Duquesne Light

July 29, 1983

Reference: Beaver Valley Power Station, Unit No. 1
Docket No. 50-334, License No. DPR-66
Request for Additional Information on N-1 Loop Operation

RSB Request for Additional Information

FIGURE 14.2-3
DLW - STEAM GENERATOR TUBE
RUPTURE EQUALIZING PRESSURE
BEAVER VALLEY POWER STATION UNIT NO. 1
UPDATED FINAL SAFETY ANALYSIS REPORT

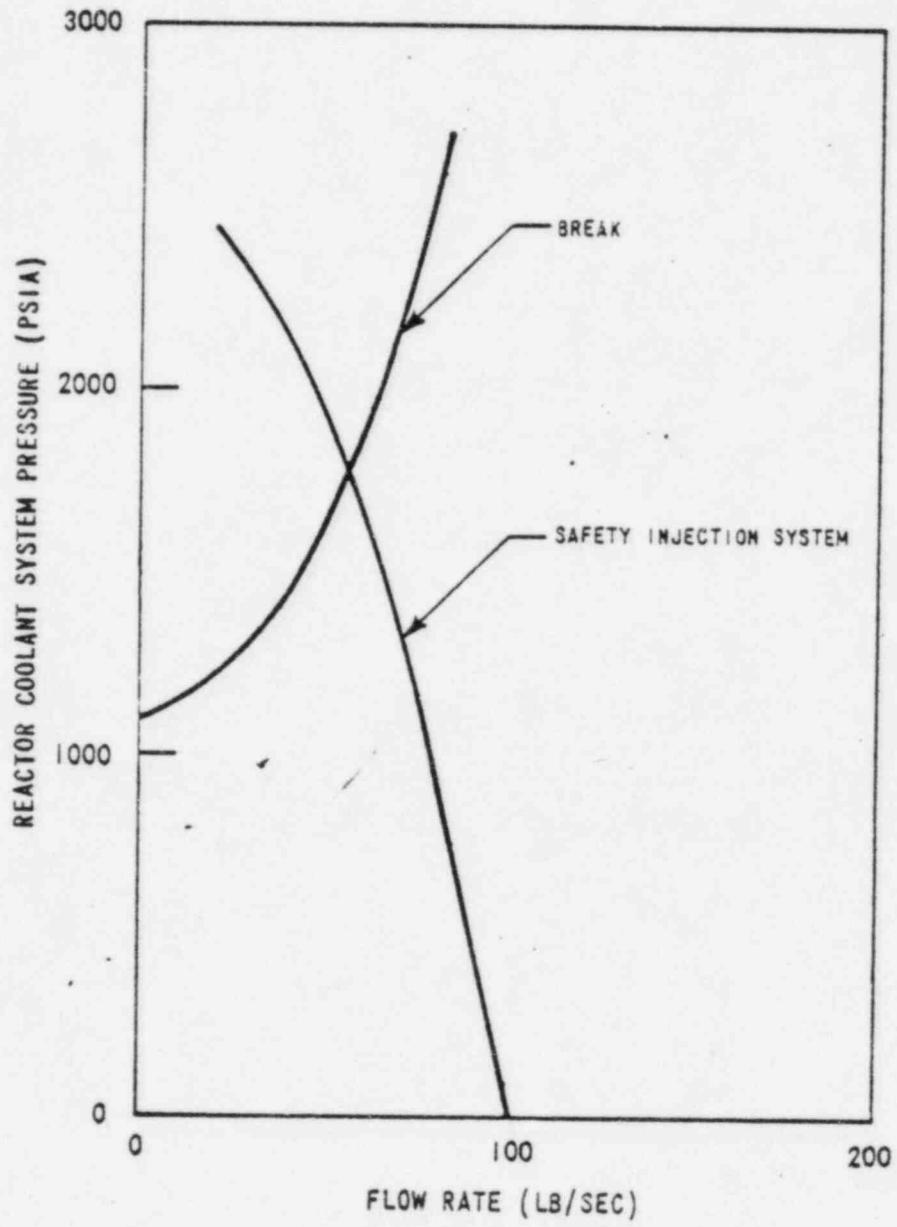
Your response to question 3 in reference 1 concerning a Steam Generator Tube Rupture (SGTR) during N-1 loop operation has been found to be inadequate. No quantitative basis was provided to substantiate your assertion that a SGTR while in the N-1 loop mode would be bounded by the FSAR calculation of a SGTR while in the N loop mode. Further, you have not provided suitable justification that the 30-minute (time to equalize RCS and faulted SG pressures) assumption in the FSAR can be met while in the N-1 loop mode. If suitable quantified bases cannot be provided, you should recalculate a SGTR in the N-1 loop mode, including an analysis of offsite dose consequences. Your analysis should specifically address the following:

4. RCS Temperature reduced to 497F prior to depressurization in accordance with SGTR procedures.
5. Charging Pump Mass input (See figure 14.2-3 Updated FSAR attached)

Attachment 0
 Figure 3.8-6
 RCS Flow
 coastdown.
 One out of two
 loop coastdown
 One loop isolate
 BYT/11-7.6.1

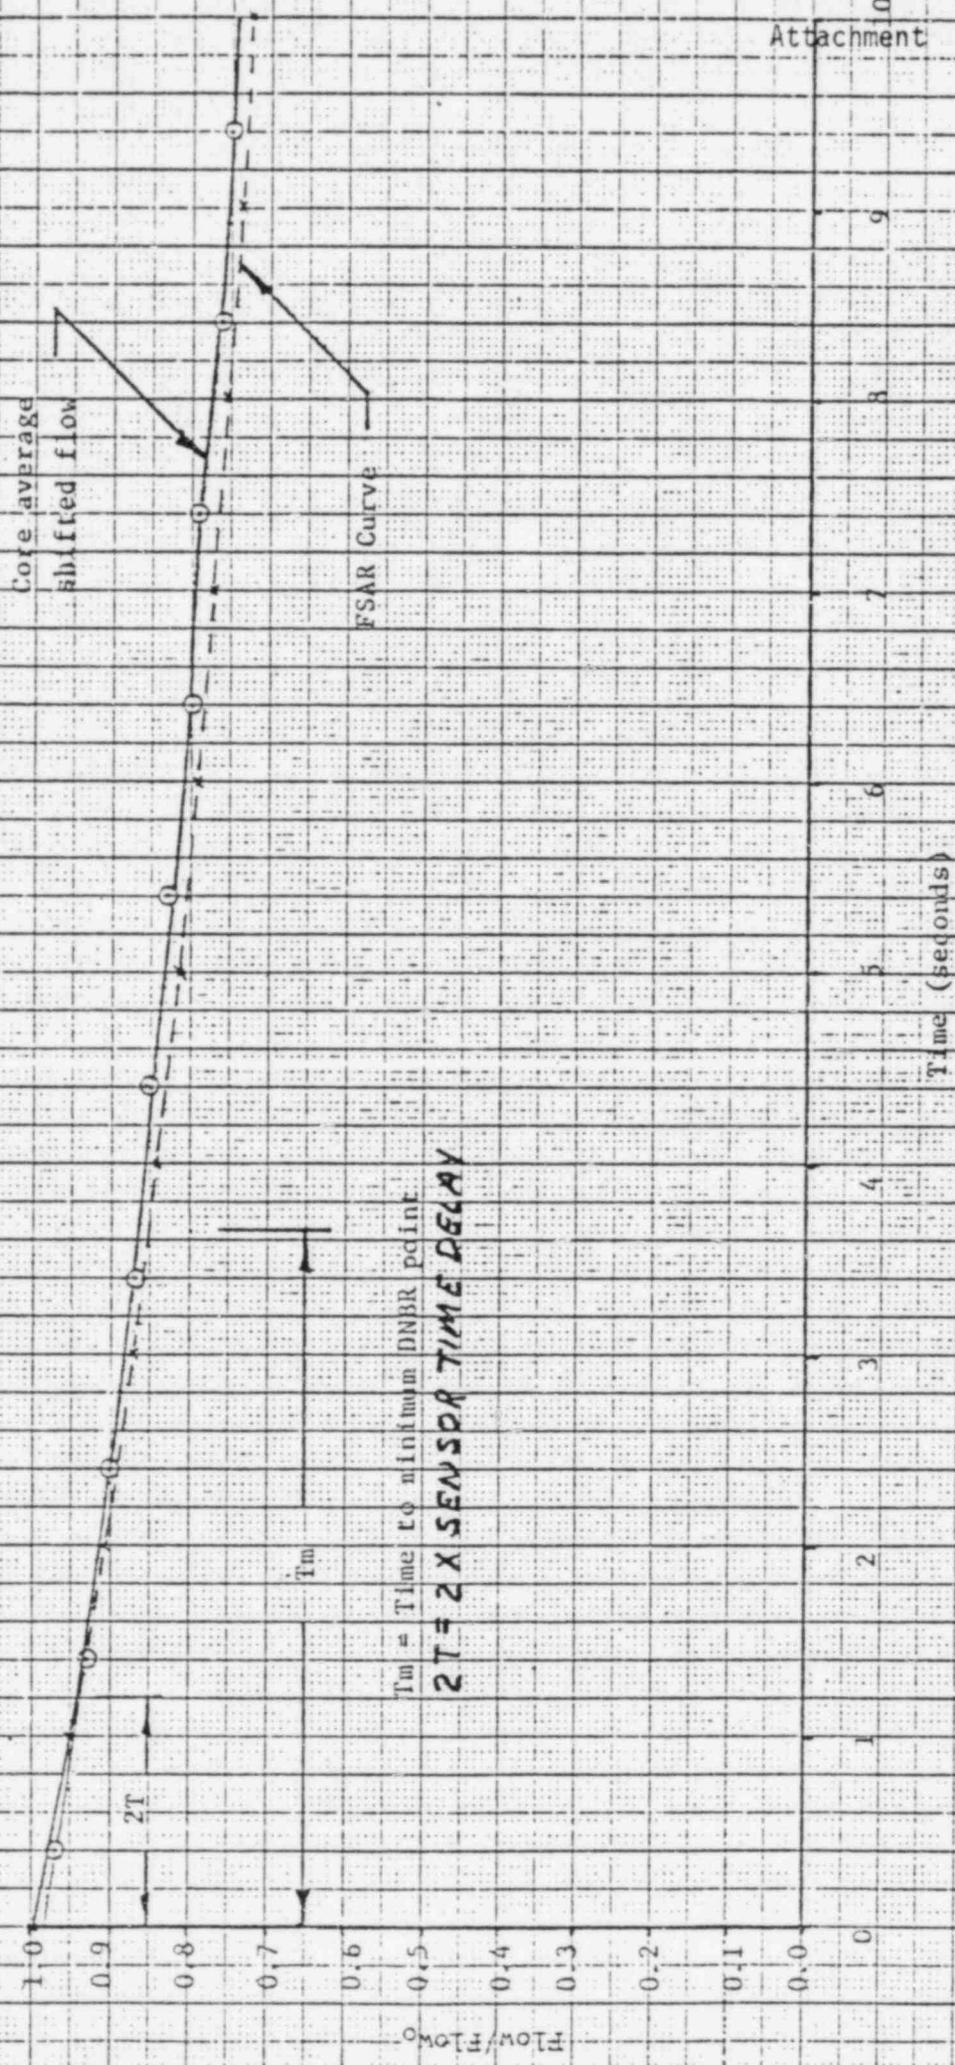
The BVPS-1 Startup Report (Initial Startup Cycle) indicates that N-1 flow coastdown measurements were performed during Initial Startup. Confirm that the data is still valid (i.e., no changes to RCS piping, reactor internals, fuel design, S/G's or RCP's have occurred which would affect the original test results in a less conservative direction).

Attached is a copy of the Test Results Report for the initial flow coastdown test (BVT 1.1-7.6.1) performed in 1976. The report identifies the case for two loop operation with a loop isolated. The test demonstrated measured core flows in excess of their corresponding FSAR curves (Reference Figure 3.8-6) for the N-1 loop case.

[The cases of two out of three loops operating with one or two reactor coolant pump(s) coasting down - one isolated loop, demonstrated measured core flows in excess of their corresponding FSAR curves (Refer to Figs. 3.8-6 and 3.8-4).] ←
